IMSAI 8080 MICROCOMPUTERASSEMBLY MANUAL ERRORS

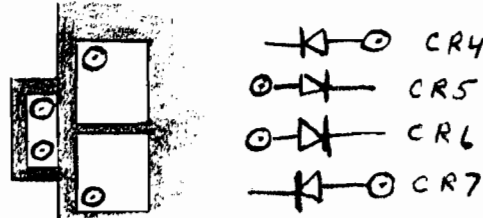
- 1) ASSEMBLY DIAGRAM (rev. 1, 5/76) - The four diodes CR4 - CR7 are shown mounted wrong. They should be mounted as follows:
